HEARING REPORT – RESOURCE CONSENT

1232 STATE HIGHWAY 1, WAYBY VALLEY

WASTE MANAGEMENT NZ LIMITED

Figure 2: Redvale Landfill methane generation predictions compared to captured methane measurements, 1997-2019 (Redvale Landfill Annual Gas Report, 14/02/2020).

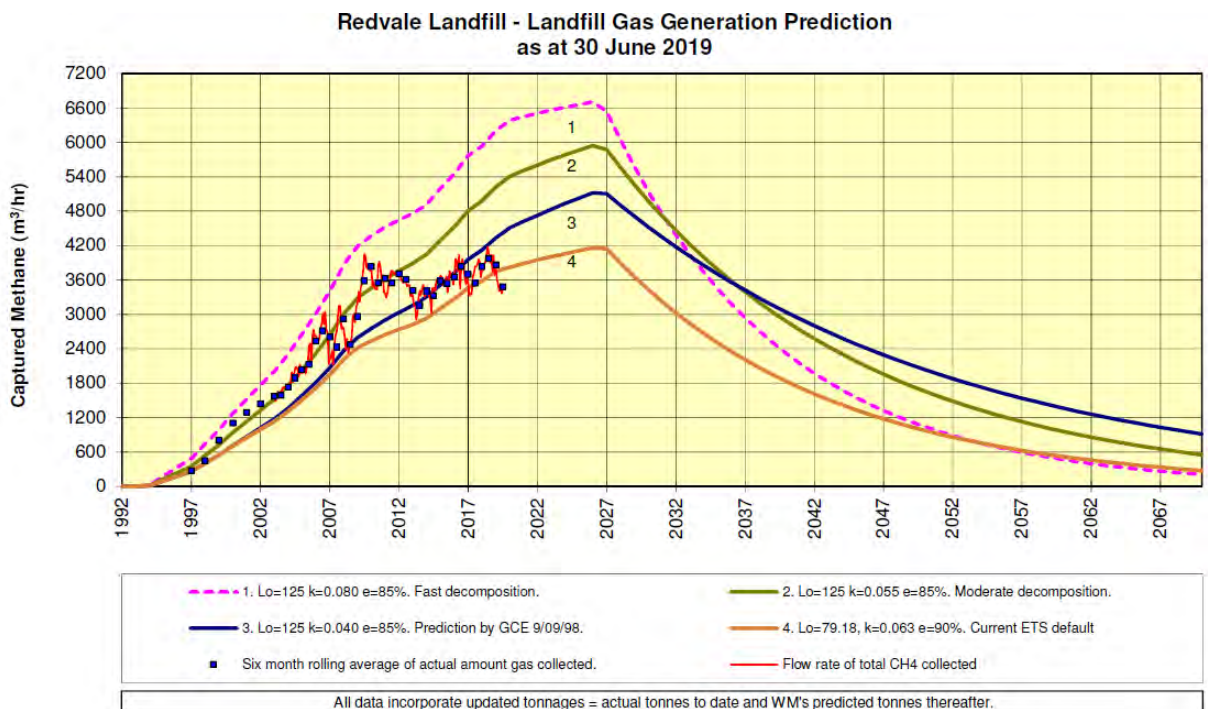
Over the lifetime of the Landfill, the AQR predicts that at least 90% of LFG generated shall be captured and utilised by the generators or flared. This is higher than the default 75% lifetime LFG capture rate recommended by AP42, although I note this average figure accounts for older landfills existing across the United States.

There is no ability to fact-check the assumed LFG generation and capture rates with certainty at this stage. However, I note that measurements of captured methane at Redvale 27 years into filling are generally tracking along the predicted curve between the above assumed upper- and lower-bound parameters ($L_0=79-100$ m³/tonne, $k=0.063$ year⁻¹, capture efficiency=90%), as shown by the measured methane collected (blue dots) compared to prediction lines 2-4 in Figure 2 below. This supports the LFG generation rates assumed for the Landfill.

Figure 3: 2013 projections for remaining airspace at Redvale Landfill with variable waste receipt rates.

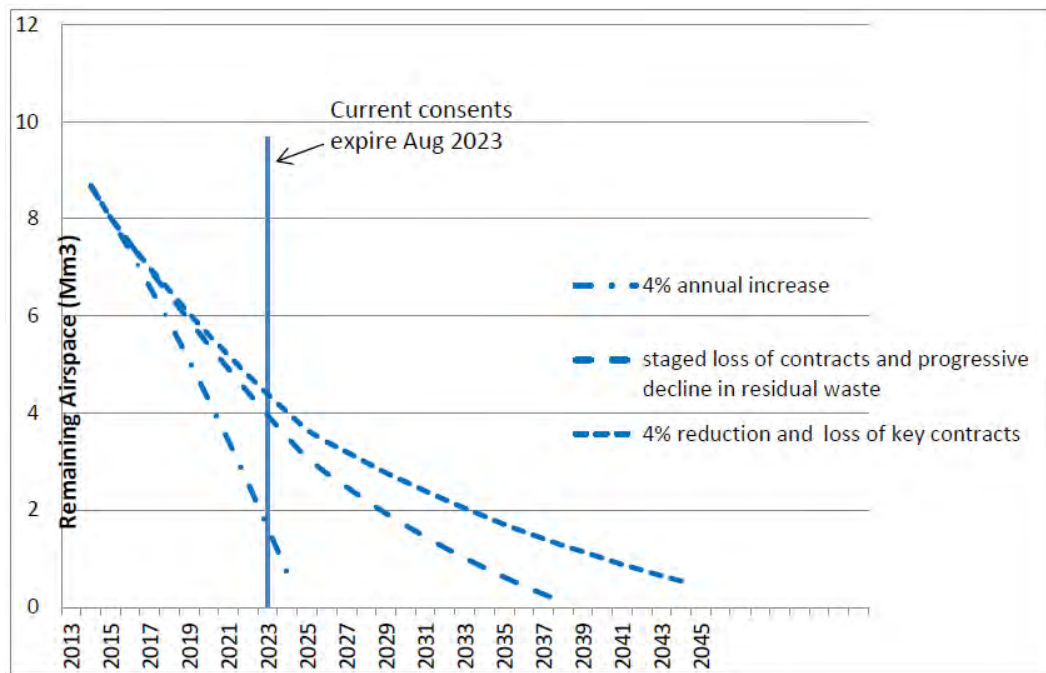
At the Consent and Environment Court Hearings for consent LAN61338 in 2014-2015, WMNZ representatives stated that there was significant airspace available at Redvale for additional waste, enabling it to continue operating possibly as long as until 2049, depending on the volumes of incoming waste (see Figure 3, taken from Ian Kennedy's (WMNZ, General Manager) evidence to the Environment Court, 17/04/2015).

The outcome of the Environment Court hearing for LAN61338 was to grant WMNZ a land-use for Redvale that states that landfilling there is to cease by 31/12/2028 (an extension of 5 years from the original 1992 consent). The AEE states that Redvale may reach filling capacity prior to this date, thereby necessitating the new Landfill. The AEE therefore considers the alternative (that Redvale continue accepting waste beyond 2028) impractical. Similarly, I consider that Whitford Landfill is likely to be filled to capacity in the coming years, making an extension of this landfill impractical.

Figure 1: Cross Section C from the Addendum Geotechnical Report, showing the proposed liner level (black line) relative to the potentially unstable surface deposits (pale green and yellow)

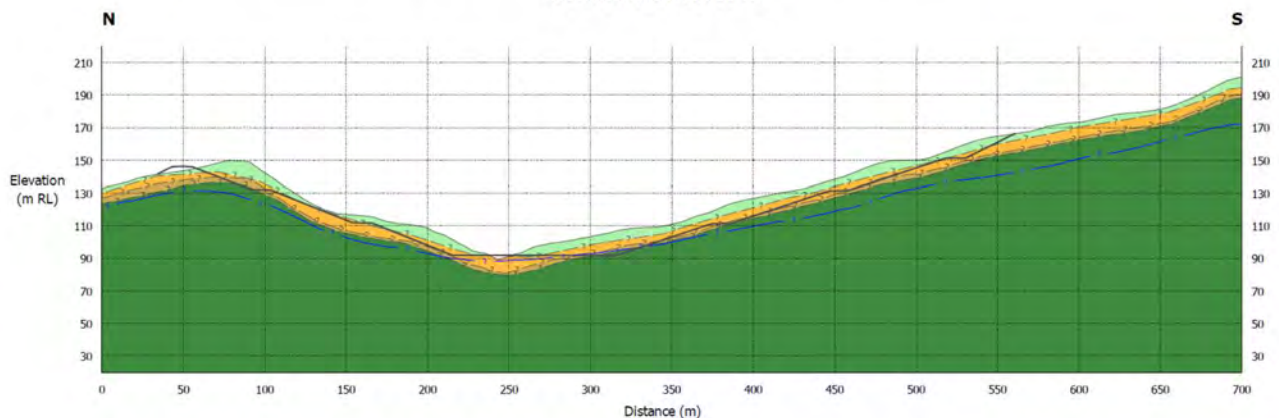
Shallow instability has the potential to be an issue during construction, when excavation into the slopes will steepen some areas. An example of this is shown in the cross section below, which shows the proposed liner level. In some areas the excavation removes the unstable shallow soils entirely, which would be expected to improve stability, while in others it cuts into and steepens these materials, reducing their overall stability.

In some areas the stability of the shallow material will be reduced. This is an expected condition of civil works in this environment and can be managed effectively during construction. Examples of the types of measures needed to manage this scale of instability are presented in the Geotechnical Addendum Report section 7.3.

Figure 2: Reaches of Stream with Residual Baseflow Reduction Concern (base image extracted from Applicant Ecological Addendum Report, August 2020)

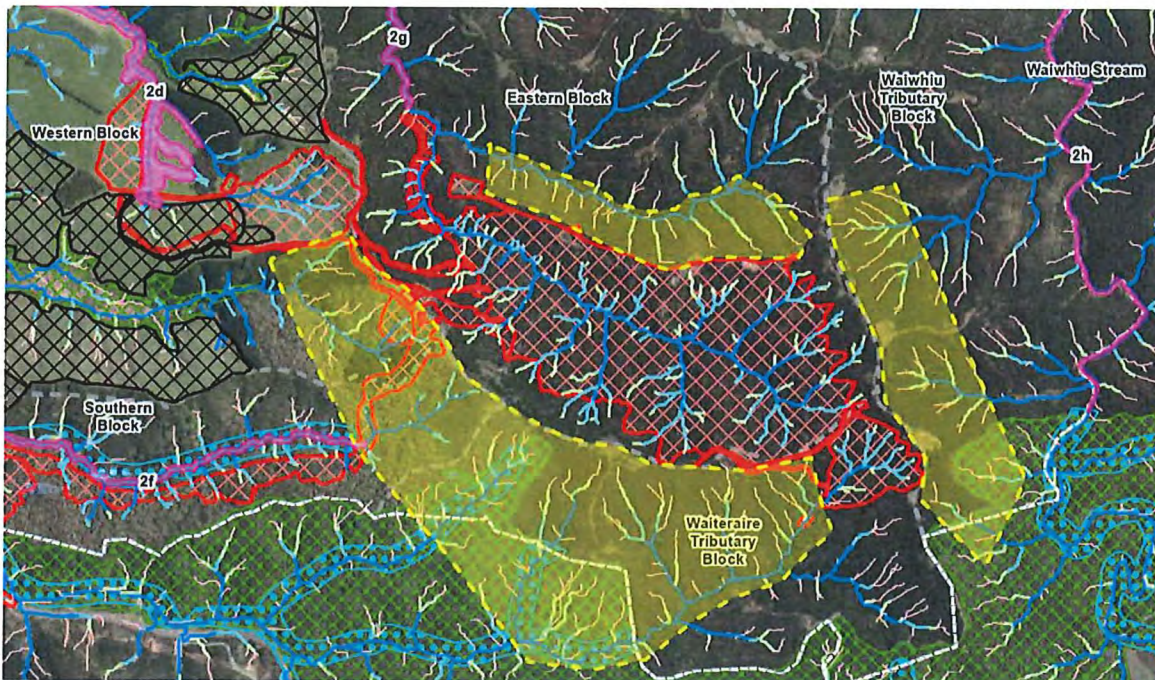
3. *Potential hydraulic impacts from sub-liner drainage and recharge reduction due to the landfill structure, ~60 ha liner, and ancillary works* – the applicant’s assessment concludes that “... the landfill is not expected to change stream flows in surrounding catchments by a measurable amount.”. My own assessment of the potential baseflow reduction in reaches of streams immediately adjacent to Valley 1 differs from the applicant’s. I estimate that some stream reaches could see up to a 20% reduction in baseflow (flow rate). This could have follow-on effects to the stream reach e.g. reduction in the permanent and/or intermittent stream lengths – and associated potential ecological effects (which are outside the area of my expertise, but may not have been assessed). The yellow dotted line + yellow shaded polygons in the Diagram 2 display the particular reaches/streams which I have residual concerns about with respect to baseflow reduction potential:
